EAGLE MOUNTAIN PLANNING COMMISSION MEETING

July 23, 2019, 6:00 PM

- 7.A. SilverLake South Preliminary Plat
A Preliminary Plat for all remaining units south of the Tickville Wash in SilverLake
[MDP under Plats.docx](#)
[SilverLake South of the Wash.pdf](#)
- 7.B. Cedar Farms - Rezone and Preliminary Plat, Public Hearing
Background: An applicant-proposed rezone from Agriculture to Residential (Parcel 59:006:0051) and a proposed two-lot preliminary plat (minimum lot size of 2.5 acres) on a 5.47-acre property.
[Cedar Farms Preliminary Plat](#)

- 8.A. Eagle Quest
A concept plan for 160 Acres
[EAGLE QUEST SURVEY EAST PARCELSignedV1.1.pdf](#)
[18-107_East Concept copy.pdf](#)

Figure 1: Project Accesses

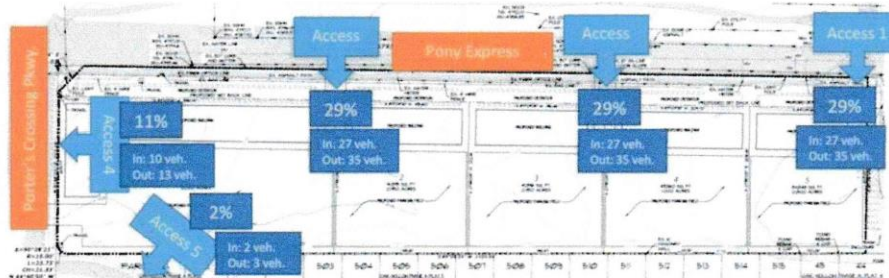
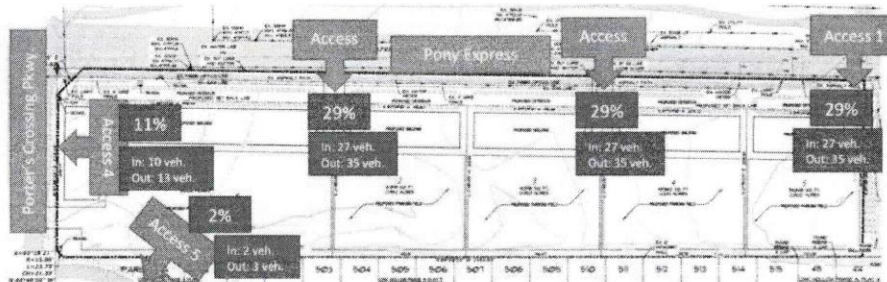
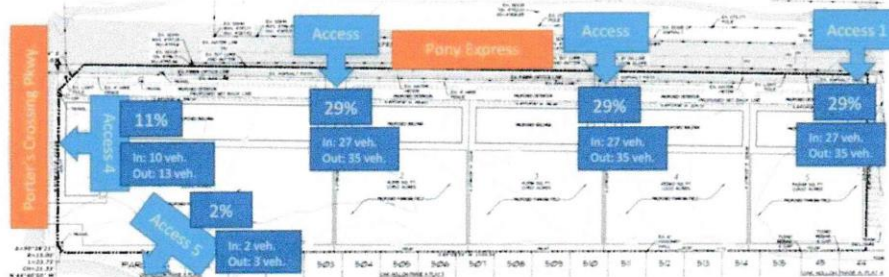
We are writing today to express my concern for the proposed "Access 5" from Bridleway Road to the new commercial property on Porter's Crossing and Pony Express.

The traffic impact study that was conducted indicated that there would only be an additional 5 cars/hr (max) that would use this access. If this is the maximum, why do we need this access? There is no other commercial plot (that I have seen) in Eagle Mountain that has direct access to a 'residential' street and even the townhouses in our area that are by commercial plot, do not have commercial access. If this access point is 'needed' so that there can be a left turn onto Porter's Crossing, why does our community have to bear the weight of this? It will lower property values, decrease safety and increase our traffic. There are plenty of options for those who need to access the communities that are on the southeast side of Pony Express to exit for the development to be able to turn left onto Porter's Crossing from Pony Express.

Access 5 overall isn't necessary to the development plan since according to the recent traffic study it would only be used for two percent of the traffic going in and out. If by chance these numbers are inaccurate and more cars are utilizing this entrance it is important that we keep families safe and stop this access from being constructed.

LITTLE USE - the new traffic impact study indicates 5 vehicles/hr at peak traffic using 'Access 5' onto Bridalway - why then, is 'Access 5' required. If the study is correct and there is only 5 vehicles, we should not even be considering this access as it is unnecessary to accommodate only 5 vehicles an hour. . The access point will only bring additional traffic through a subdivision that is not designed to handle traffic.
(<https://drive.google.com/file/d/1x00d9AXUMs5qhuuEjySf9aLxNt8rXv6a/view?usp=drivesdk&fbclid=IwAR1XAHON08eQ2VJdI44Z7XKcxORbTVkD1mTavvgMTzWBY1w2uIPdhsejttU>)

Commercial development on Utah County parcel 58:040:0542 intends to connect directly to Bridleway Road. This petition is to voice opposition against this business access to a residential community, Oak Hollow. Please sign this petition if you are opposed to Access 5.

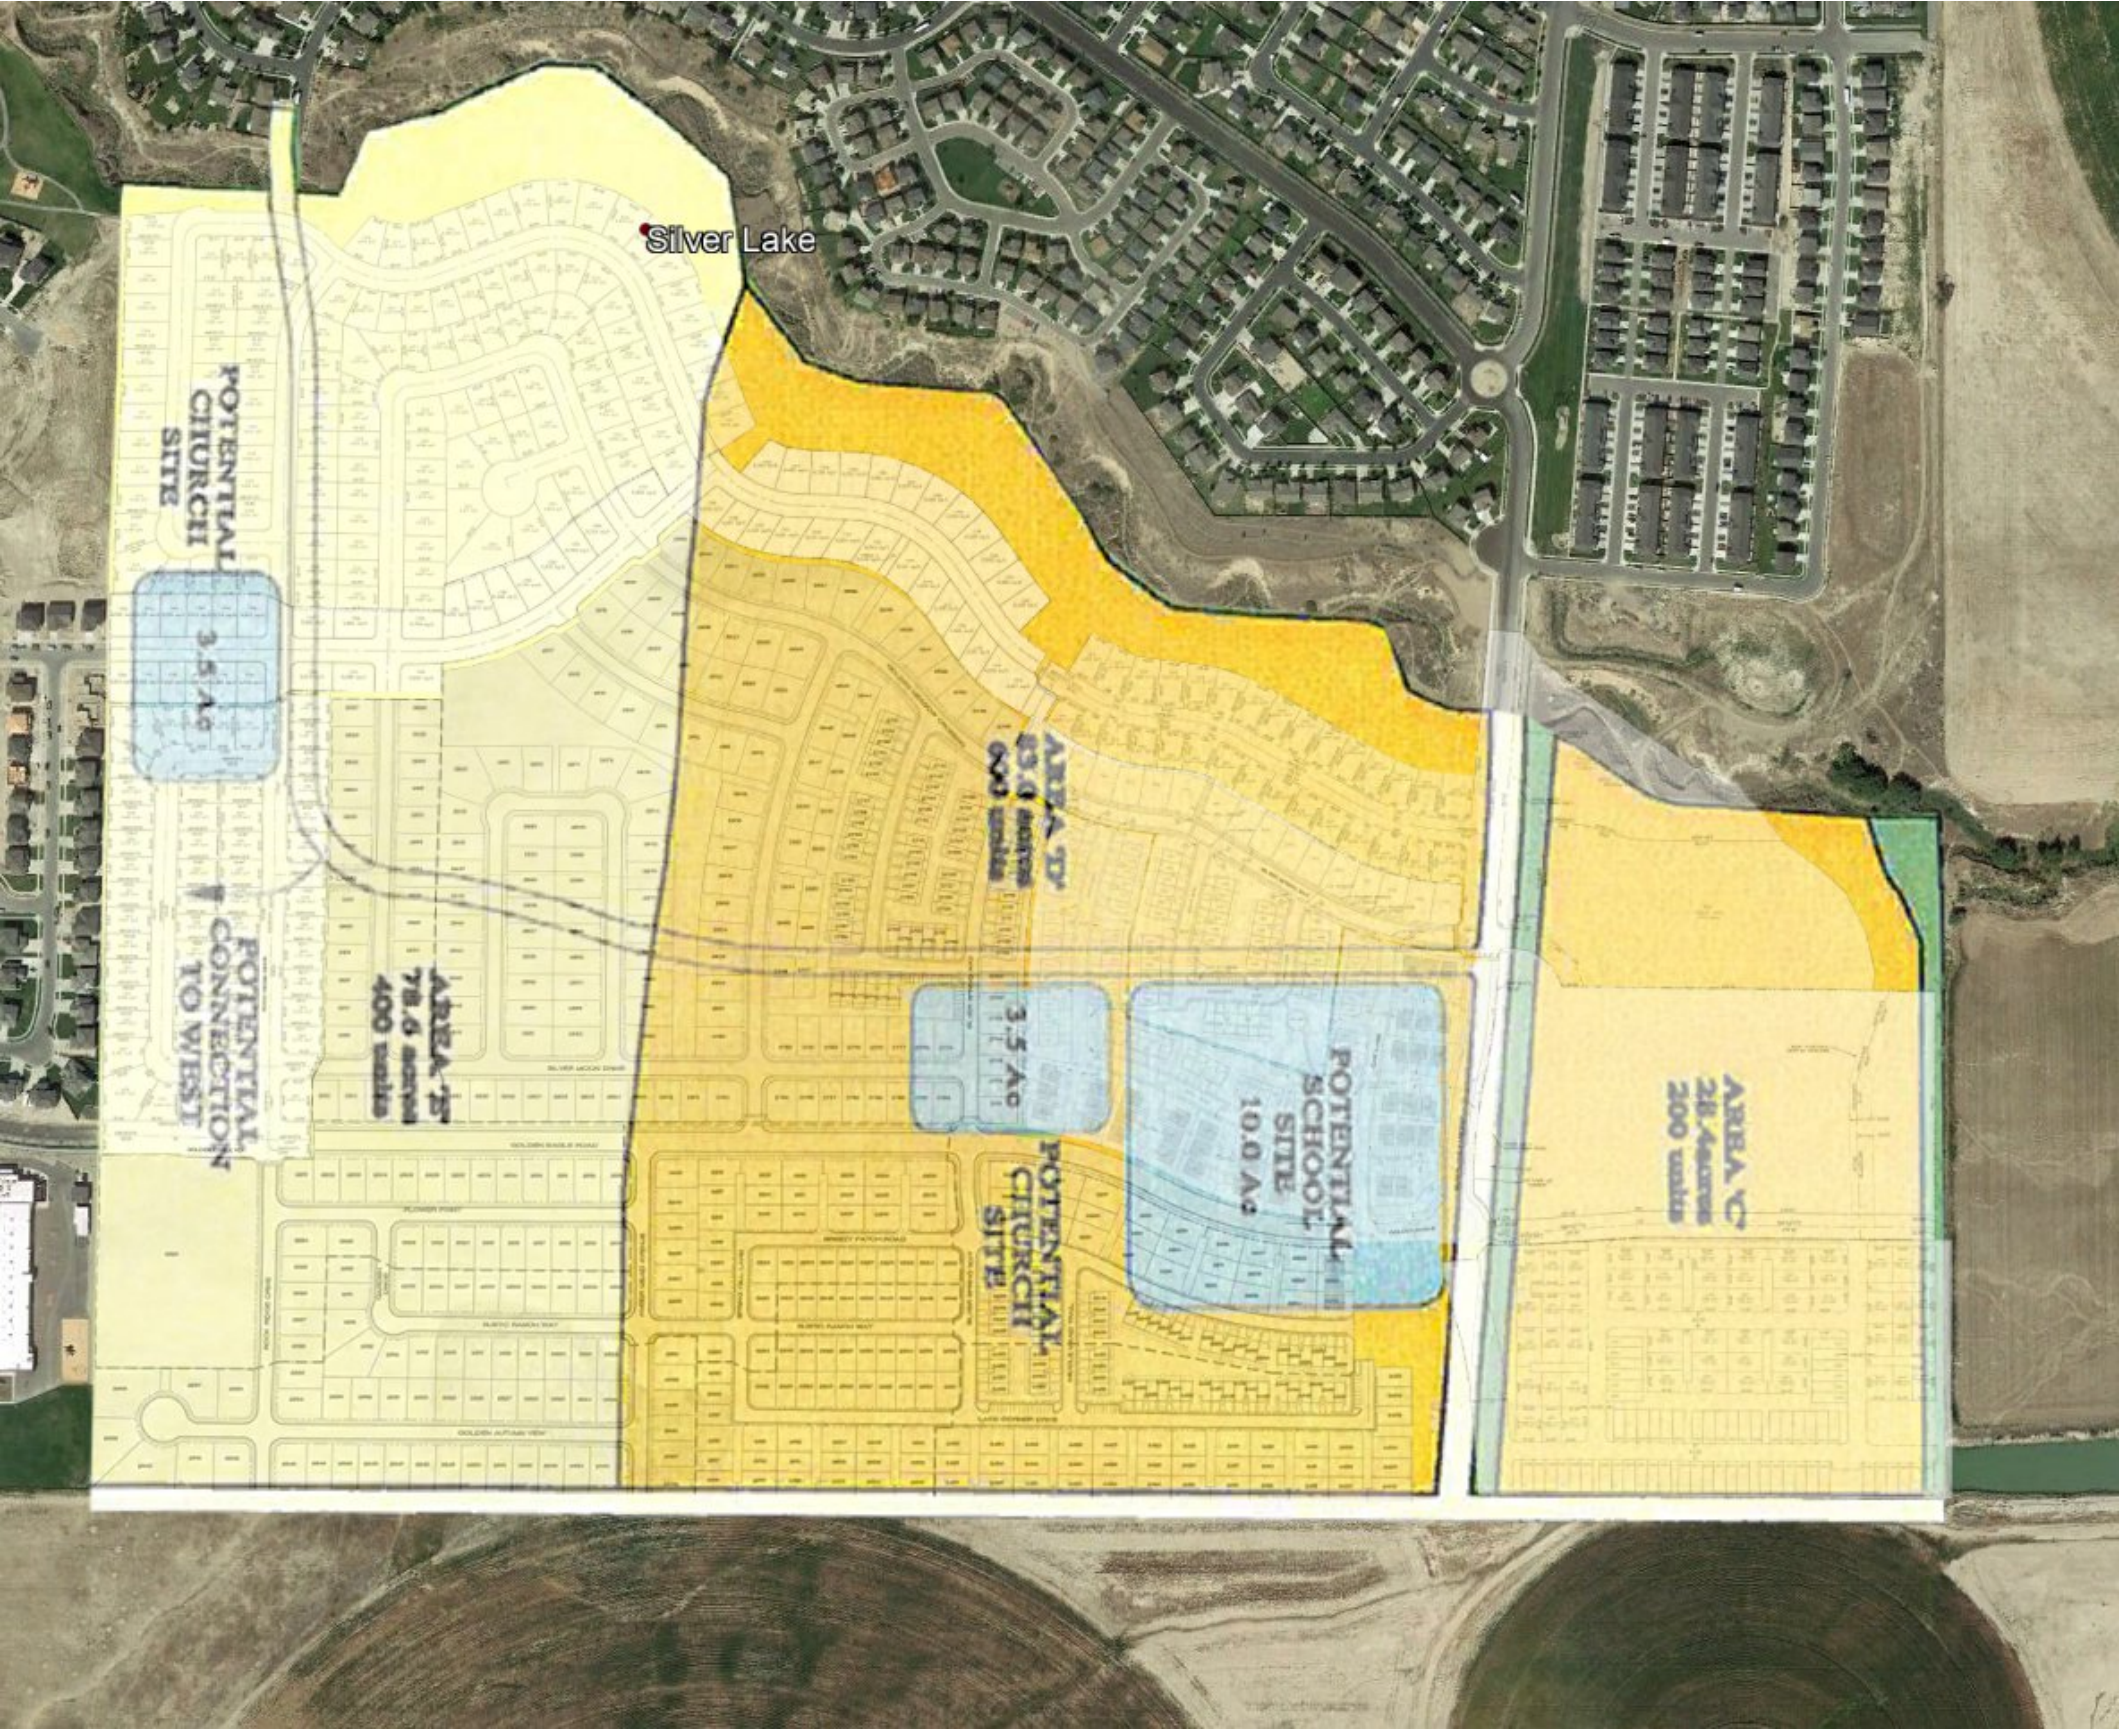
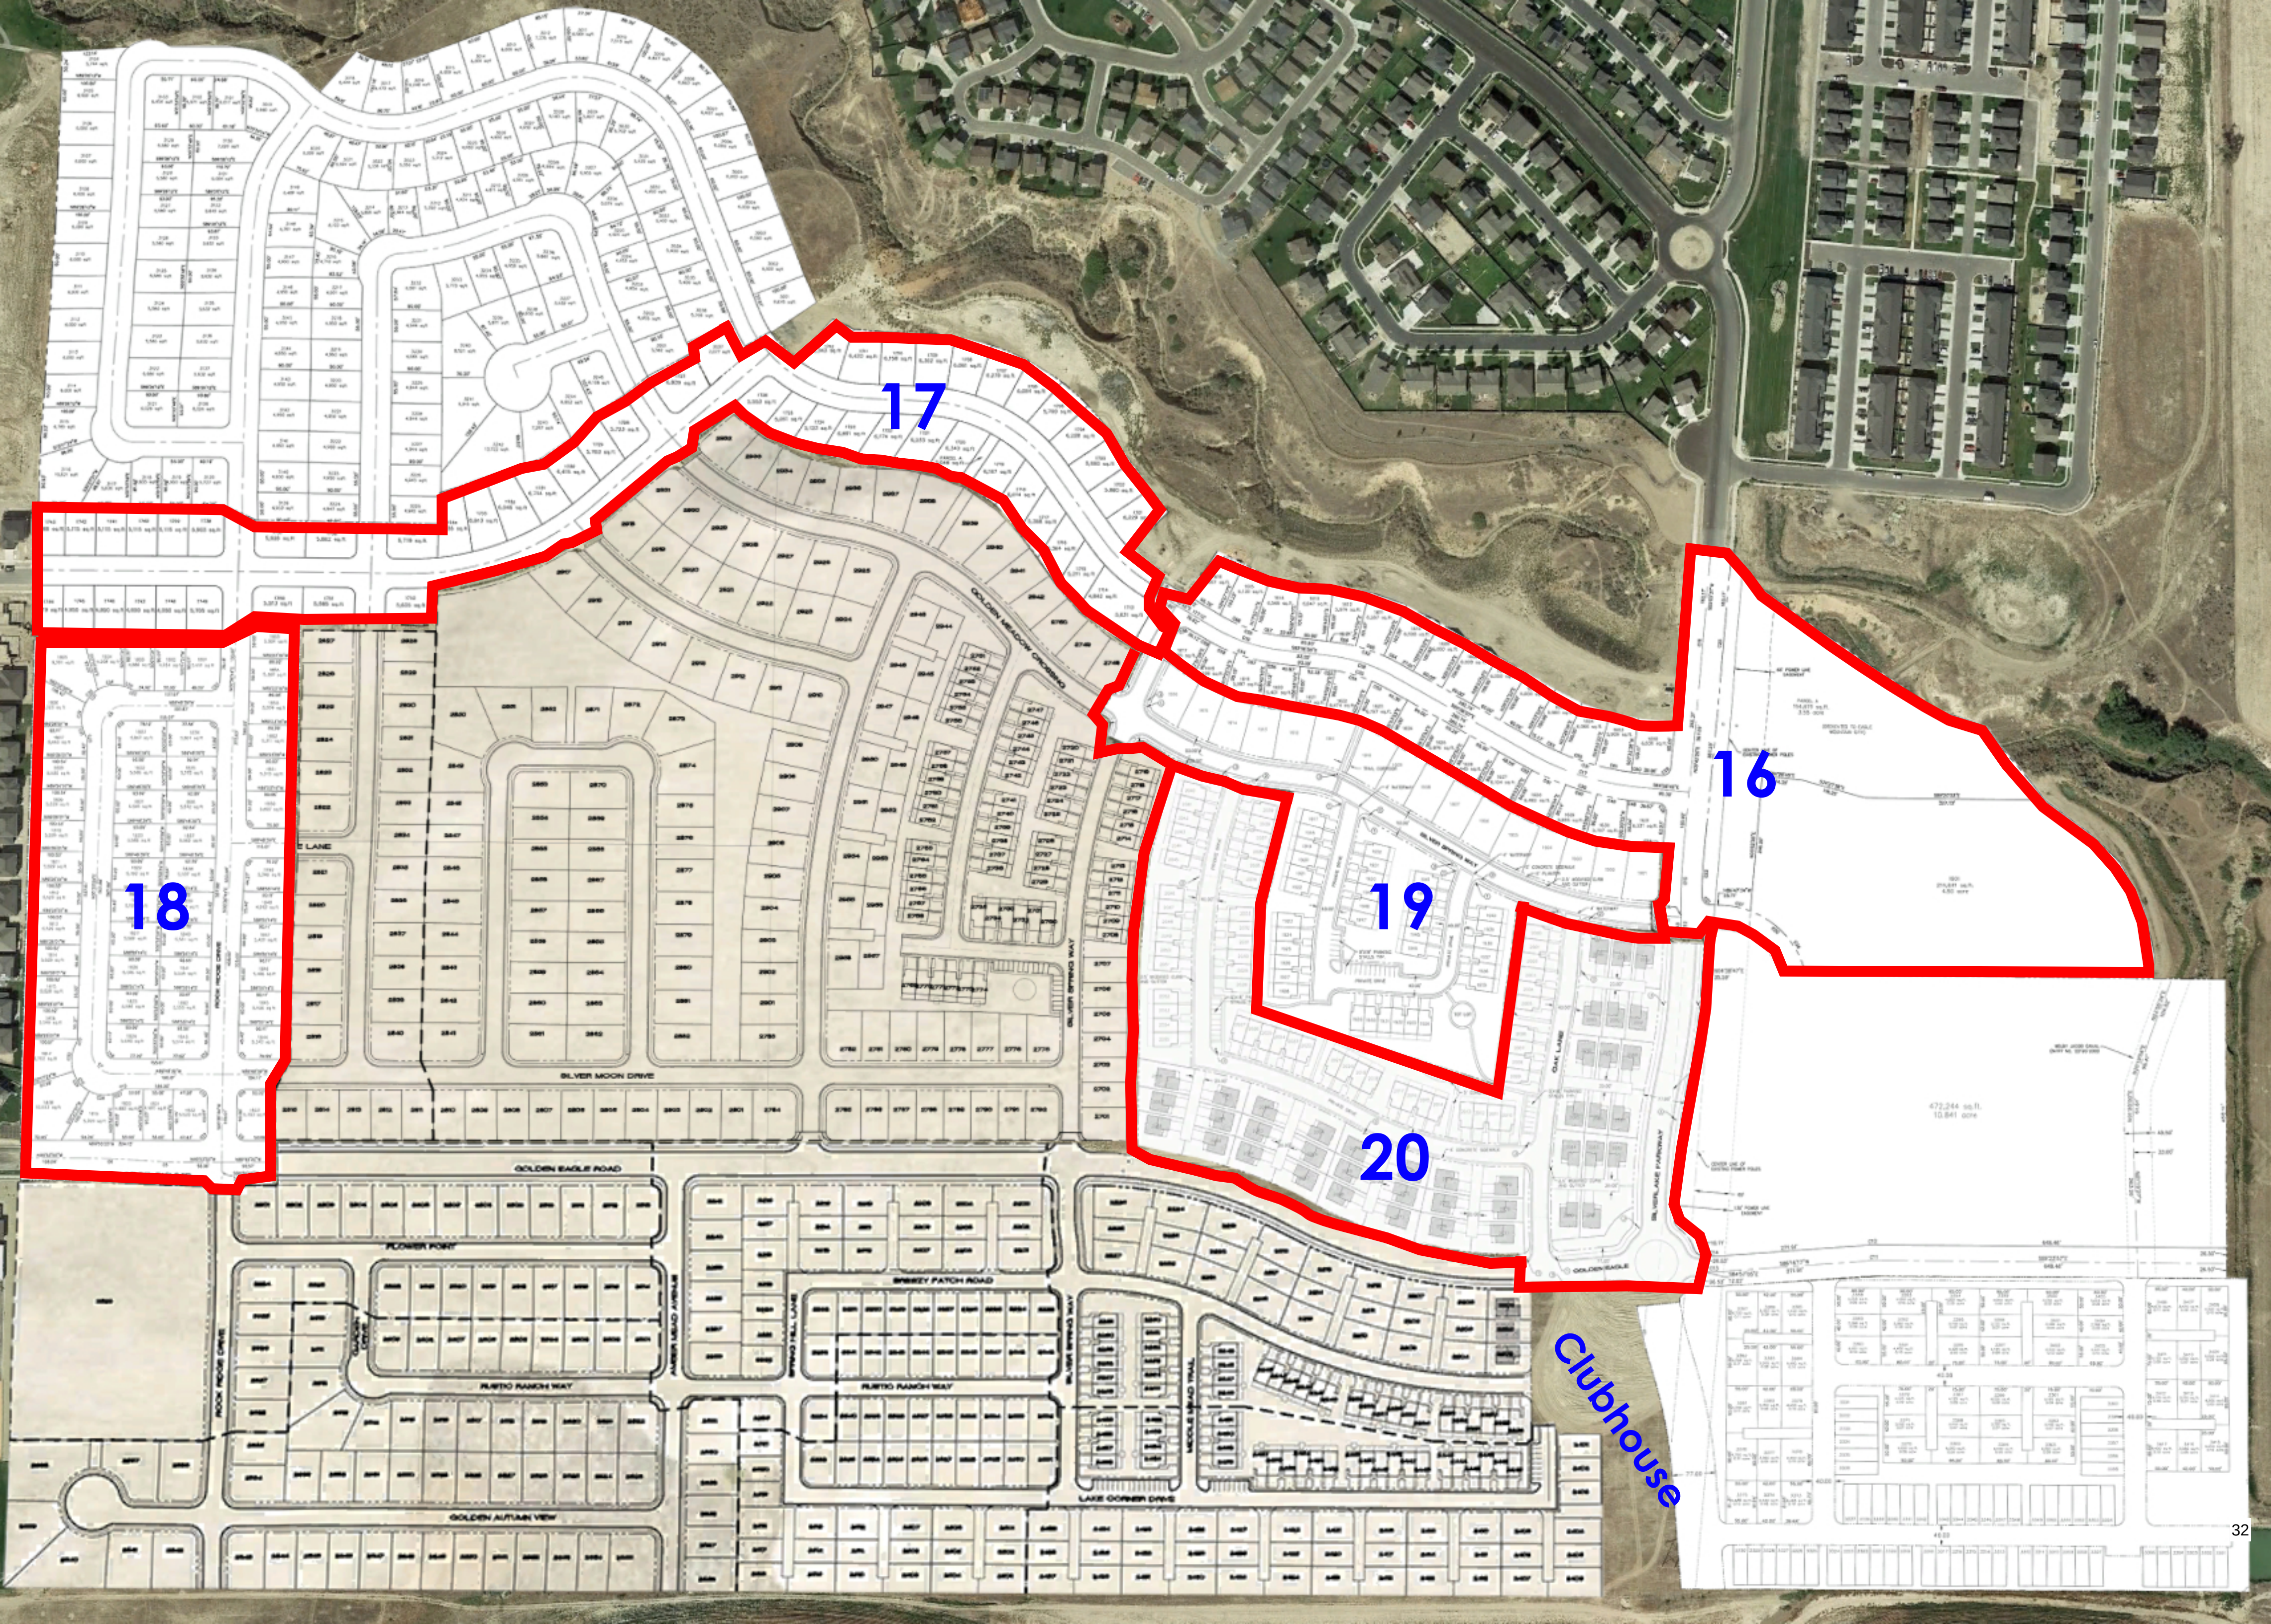
Per the SilverLake MDP Paragraph 6b the Applicant is required to provide 14.541 acres of Improved parks throughout the development, 5.789 Acres were provided north of the wash, thus the applicant shall demonstrate that at least 8.752 acres of improved open space is provided south of the wash.

PARAGRAPH TWO: This is the Final Preliminary Plat for SilverLake, thus the Planning Commission shall review the proposed parks plan and indicate if you feel it is appropriate. Staff believes that more park space should be included in a centralized park that includes playfields. Staff believes that the narrow section of land between the lots in the center of the project should not be improved open space due to the narrow nature of the property and lack of visibility from public streets.

PARAGRAH FOUR: The SilverLake MDP shows a road crossing the Tickville Wash at Silver Creek Way, the proposed Preliminary Plat does not show this connection. It is the opinion of staff that this connection should be shown to increase connectivity between the subdivisions on the north and south side of the wash

I move that the Eagle Mountain Planning Commission Table the SilverLake South (Plats 21-26) Preliminary Plat until the following items are completed:

- 1) A road is shown connecting over the wash into Silver Creek Way
- 2) A Detailed Parks Plan has been submitted and approved by the Parks Director
- 3) Any Other Items the Planning Commission feels are appropriate
